**Exception Request No.: 15**  
**Section: WBR3**  
**Town: Campton**  
**Highway: US 3 (Tier 2)**  
**Station: 2418+50±**  
**Drawing No.: WBR3 C210**  
**Survey Report Cross Reference No.: WBR3 C206**  
**Exception Type: Crossing Over Existing Drainage Structure**

EXCEPTION 15-CROSSING OVER EXISTING UTILITY/DRAINAGE  
 NPT WBR3-UNDERGROUND ALIGNMENT  
 WBR3 SECTION-STA. 2418+50  
 SCALE: DATE: 05/20/17

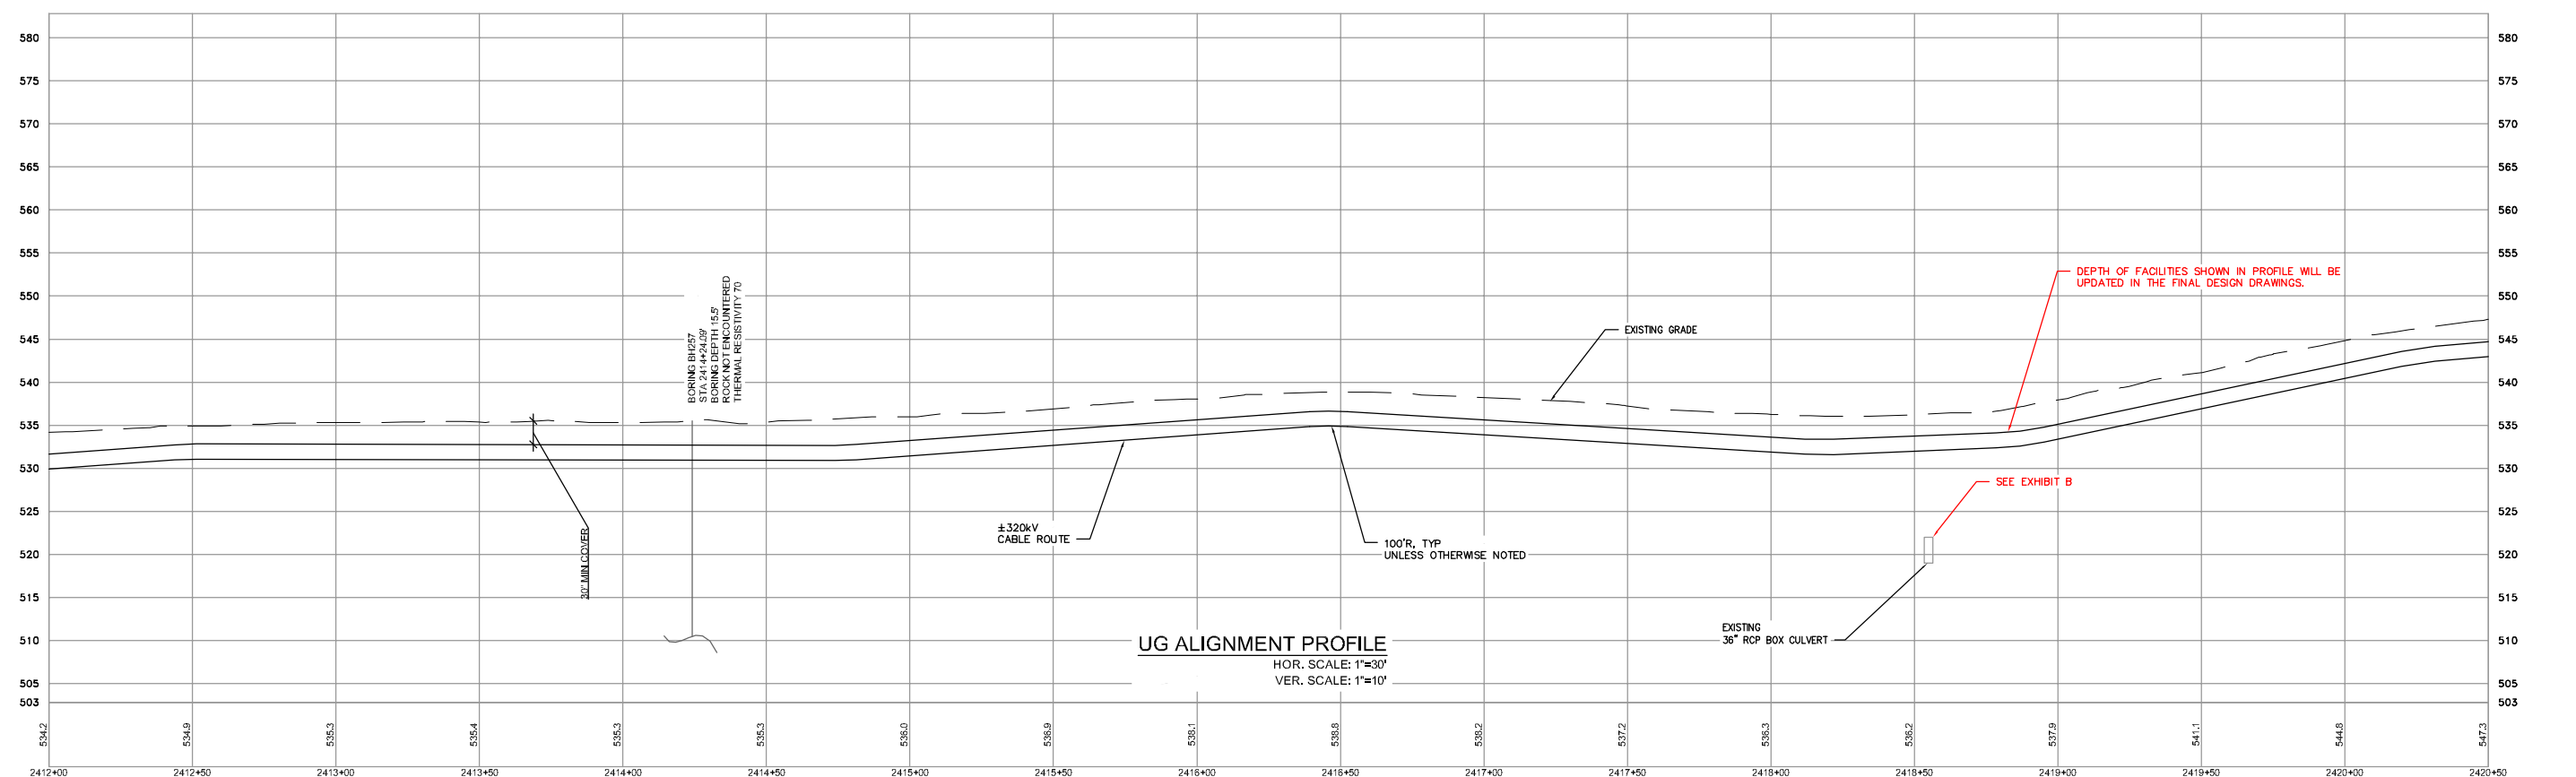
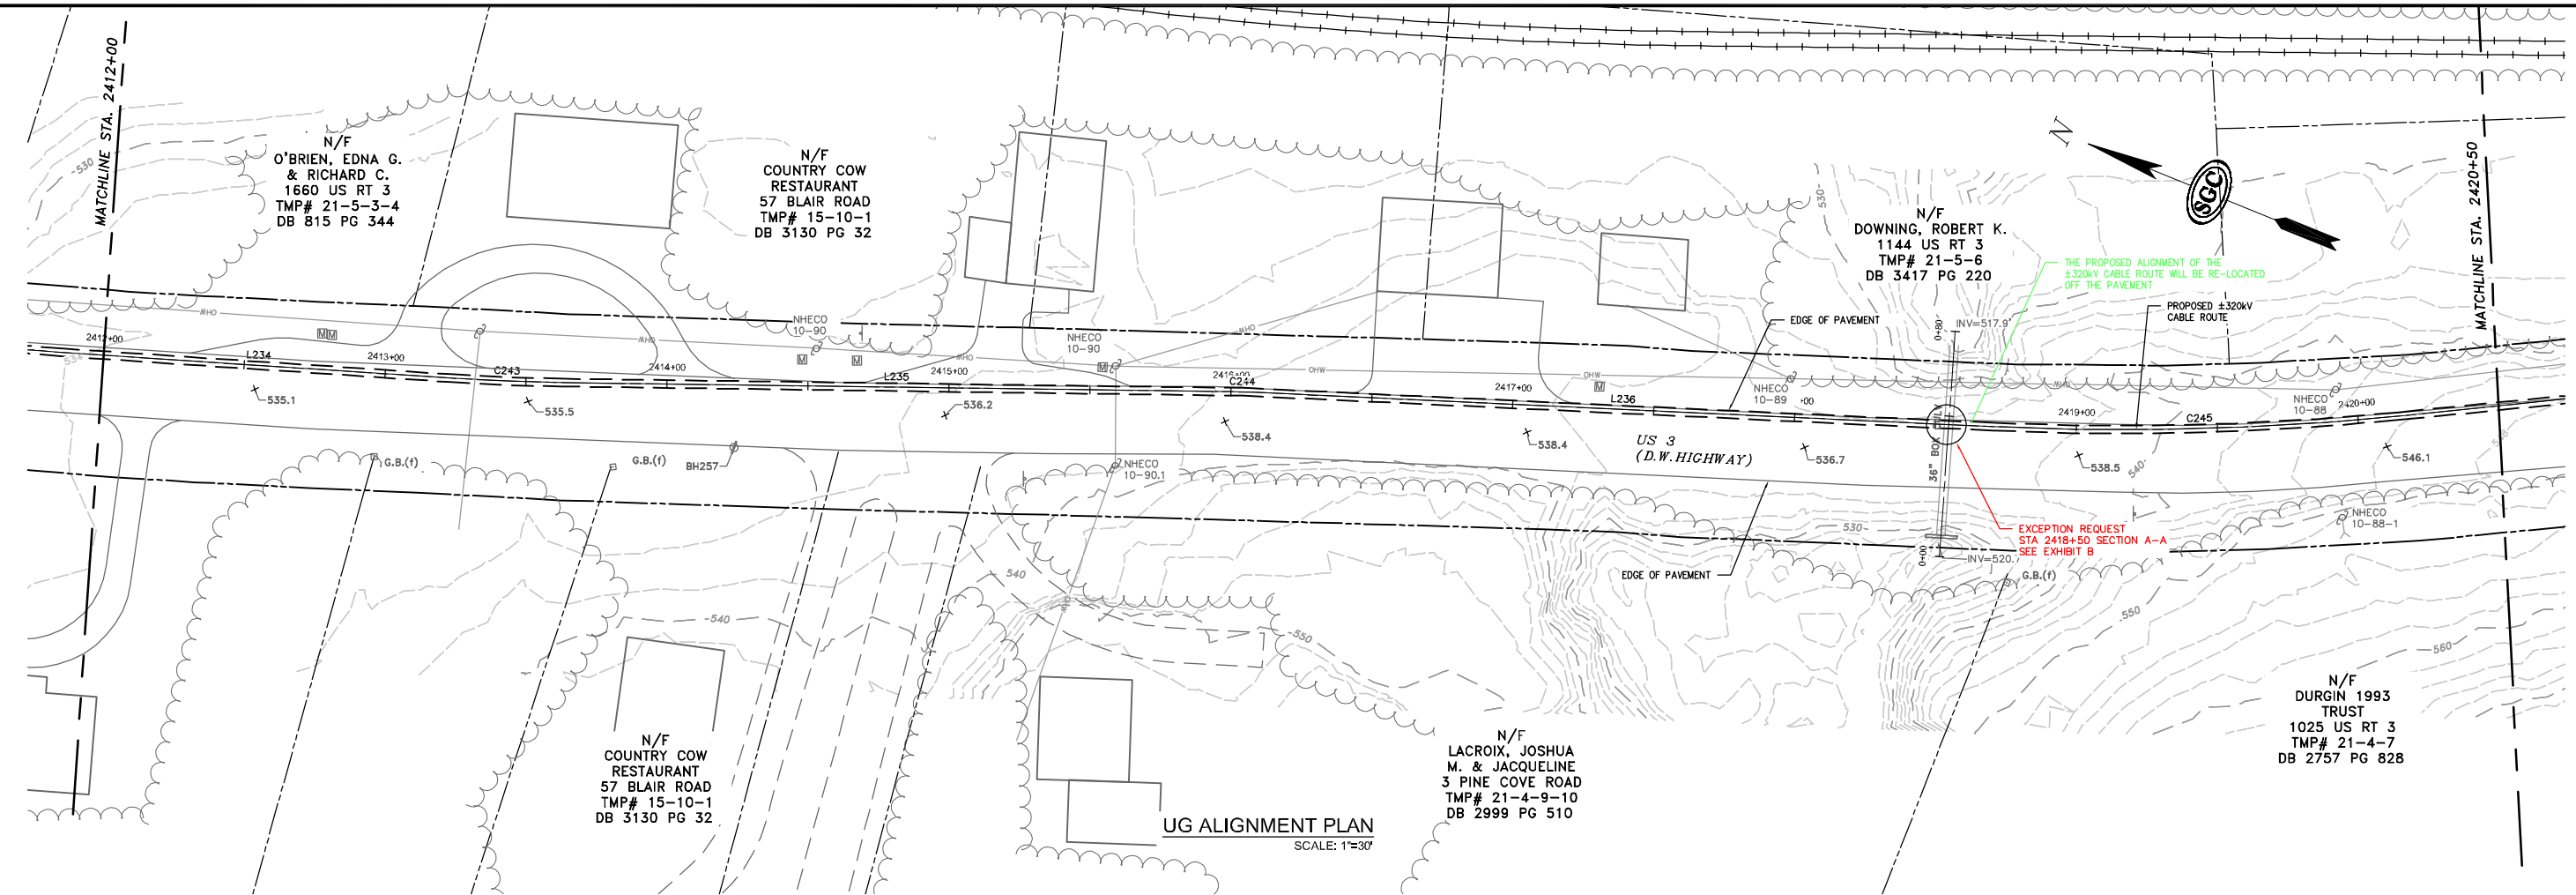
NPT is requesting an exception from the UAM guidelines for crossing above an existing 36-inch reinforced concrete box culvert on US 3, Daniel Webster Highway at station 2418+50±. (See Exhibit A). There is 14 feet of cover over the culvert. The proposed alignment in this area will be set outside the pavement. The alignment is proposed over the existing drainage structure to avoid road closures or other significant traffic impacts, unreasonable costs associated with a deeper excavation, and increased construction width which will extend the duration of construction and traffic impacts. The attached exhibits have been provided for this location to illustrate the constraints associated with installing the ductbank below the existing culvert.

The vertical positioning of the cable trench is constrained by the depth of the existing culvert (fourteen feet to the top of the culvert). (See Exhibits A and B). Crossing under the existing culvert to meet the required 2-foot minimum separation will require a greater separation of the conduits and cable to accommodate shoring and thermal design criteria for the electric cables resulting from the additional depth. This trench width and additional offsets necessary for construction would likely require either complete road closures or result in significant traffic impacts, including extended duration of construction within roadway to allow for sheeting installation and removal and extensive excavation due to the depth and width of the trench. We estimate that these construction alternatives will add one to two weeks to the traffic impacts. Finally, we estimate the increase in cost associated with crossing underneath the culvert would be approximately \$248,000 for this 200 foot section. (See Exhibit C.) Road closures are not needed for the proposed installation, which thereby minimizes traffic impacts and attendant safety issues.

At all locations where the new ductbank is constructed over an existing drainage structure or utility, NPT will add rebar to the concrete encasing of the ductbank for a 15-foot section on each side of the crossing to form a 30-foot self-sustaining bridge that will allow for excavation under the duct bank for purposes of future maintenance of existing utilities or drainage structures. In connection with future maintenance activities, especially related to the culvert, NPT will provide any and all required support, including but not limited to, providing crews to assist while work is being conducted in the vicinity of the culvert.
